MEMORANDUM

To: Anthony Shute, Director of Community Development, City of El Cajon
From: Sharon Toland, Project Manager, Harris & Associates
RE: Truck Noise and Delivery Van Backup Beeper Noise Evaluation for the Weld Boulevard Distribution Center Project
Date: March 2, 2021
CC: Darin Neufeld, Diane Sandman, Ryan Binns, Harris & Associates
Susan Guerra, Lee Chesnut, Chesnut Properties
Att: 1, Van Parking Evaluation Review, Acoustical Study

Re: Van Parking Evaluation Review, Acoustical Study
Weld Boulevard Distribution Center, El Cajon, CA
NV5 Project 2020188.00

Figure 1

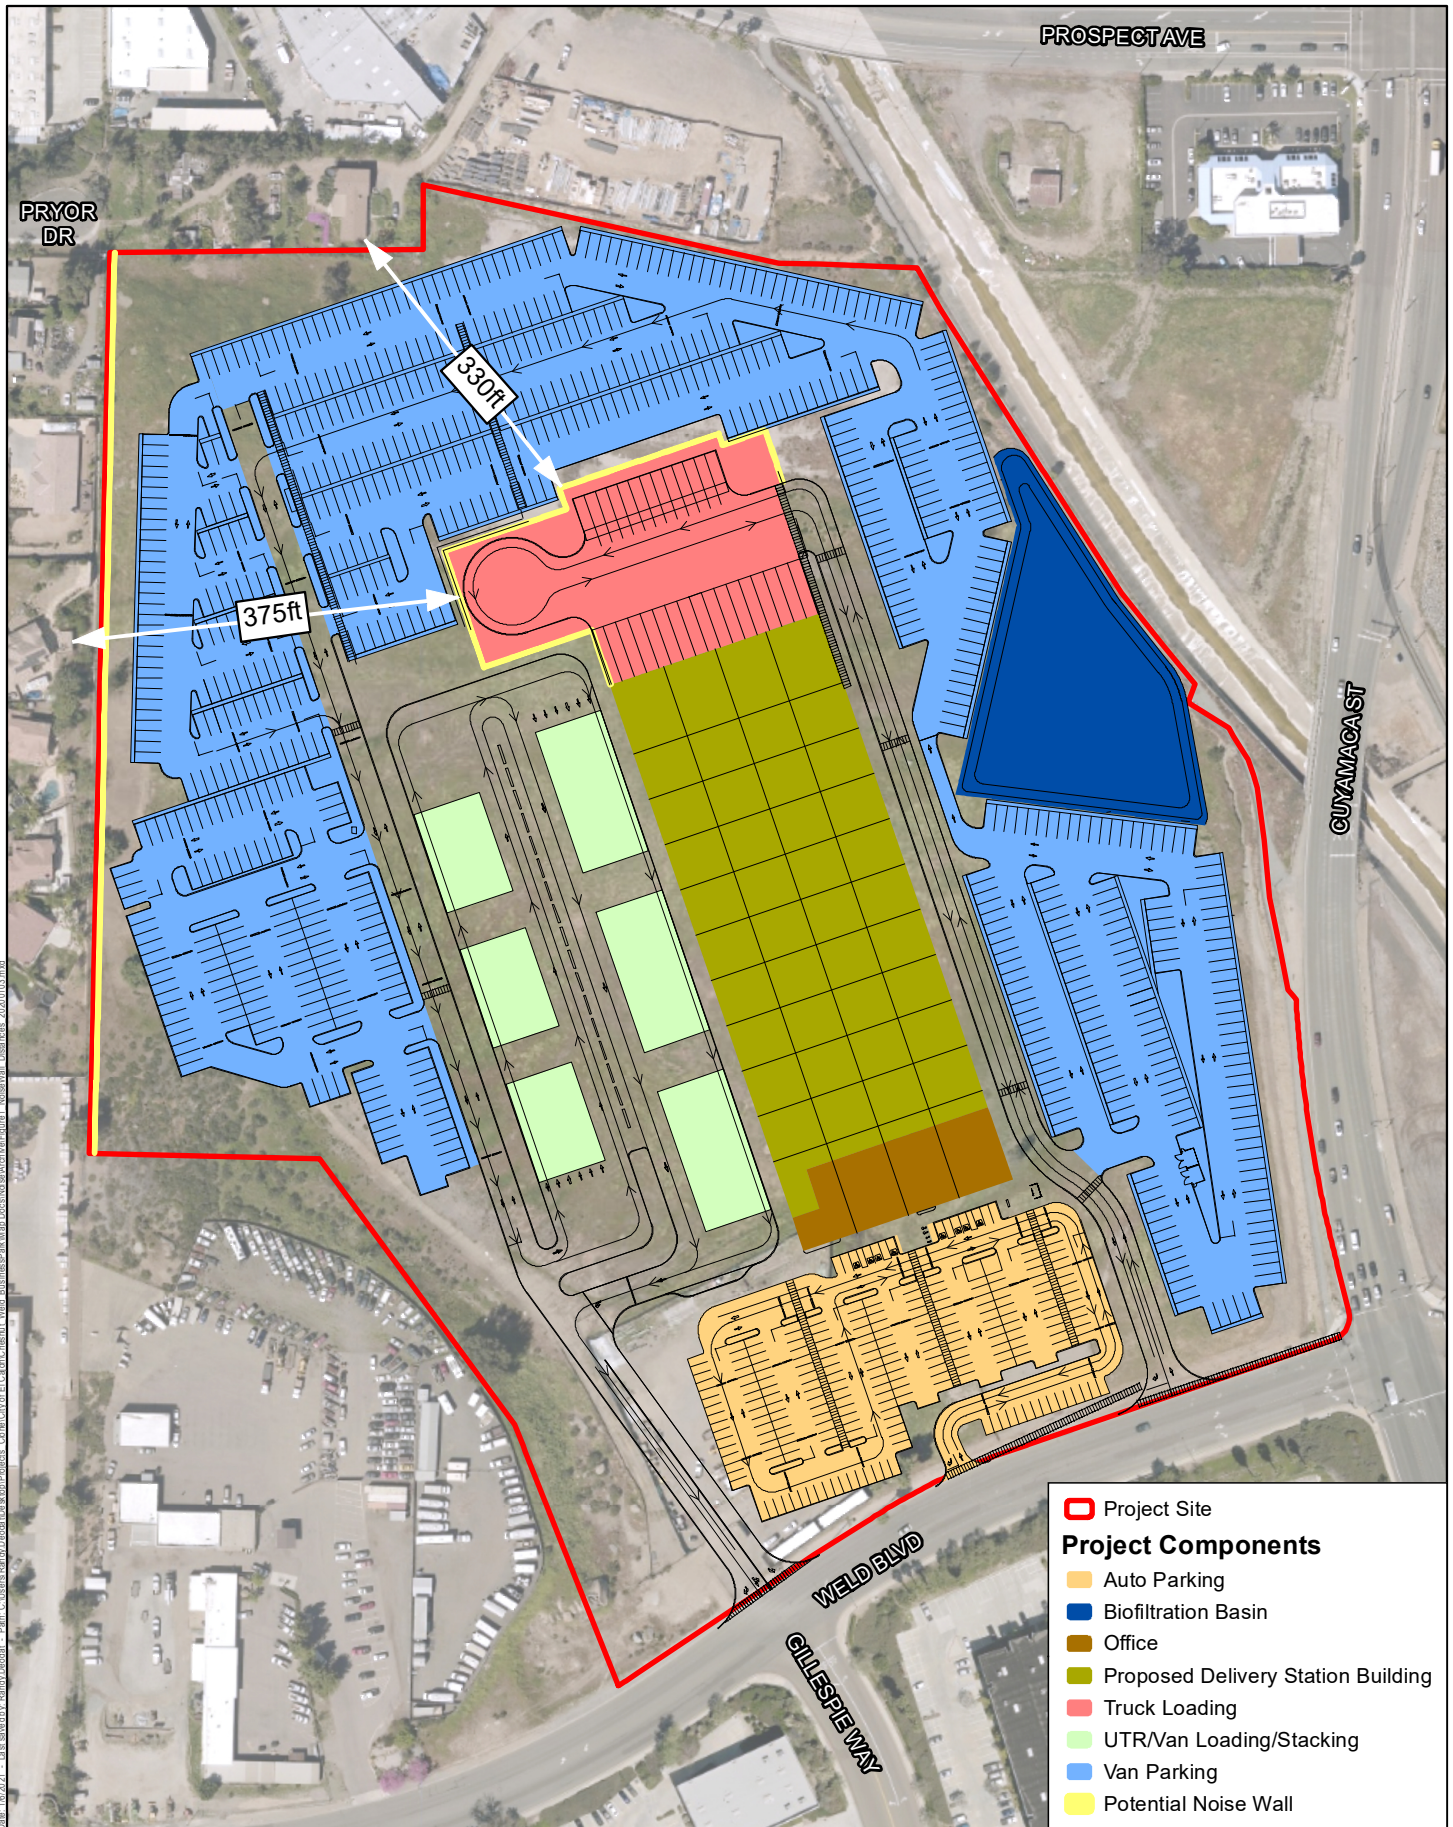
The project applicant is proposing to construct a 6-foot-high solid wall on the western side of the project site and an 8-foot-high solid wall surrounding the truck loading area (see Figure 1, Noise Reduction Options). These design features are discussed below.

Sensitive residential receptors are north and west of the project site (see Figure 1). The residential receptor north of the project site is approximately 330 feet from the proposed truck loading area. After implementation of the proposed project, the receptor to the north and the truck loading area would be at approximately the same elevation (354 feet above mean sea level [AMSL] and 360 feet AMSL, respectively). As previously stated, the maximum noise level from truck deliveries would be approximately 60 dBA at this receptor without any additional noise attenuation. However, a wall may be constructed along the entire perimeter of the truck loading area, except at the entry and exit on the eastern side of the proposed building area. A barrier 8 feet in height is calculated to provide an approximately 4 dBA noise reduction and would reduce maximum peak-season noise levels to 56 dBA at the residence north of the project site.

The residences west of the project site are approximately 375 feet from the proposed truck loading area. These receptors are at a higher elevation (384 feet AMSL) than the project site (360 feet AMSL at the truck loading facility). Maximum noise levels from truck deliveries would be approximately 60 dBA at these receptors without any additional noise attenuation. An 8-foot-high wall along the perimeter of the truck delivery area, as described previously, is calculated to reduce maximum peak-season noise levels to 56 dBA at these receptors. A 6-foot-high wall would be constructed at the western project boundary at the top of the slope and at the same elevation as these residences. Assuming a barrier is installed at the project boundary only, a barrier 6 feet in height at the western perimeter is calculated to provide an approximately 7 dBA noise reduction and would reduce maximum peak-season noise levels to 53 dBA. Installation of both barriers is calculated to reduce maximum peak-season noise levels to 49 dBA, a reduction of approximately 11 dBA.

The proposed noise wall on the western perimeter of the project site would also reduce noise exposure from parking lot noise. Assuming a worst-case individual noise event of 67 dBA at 60 feet at the nearest residence, a 6-foot-high wall would provide an approximately 5 dBA noise attenuation and reduce maximum noise levels from the nearest parking spaces to 62 dBA. Based on the measured noise level provided by NV5 (2021), delivery van
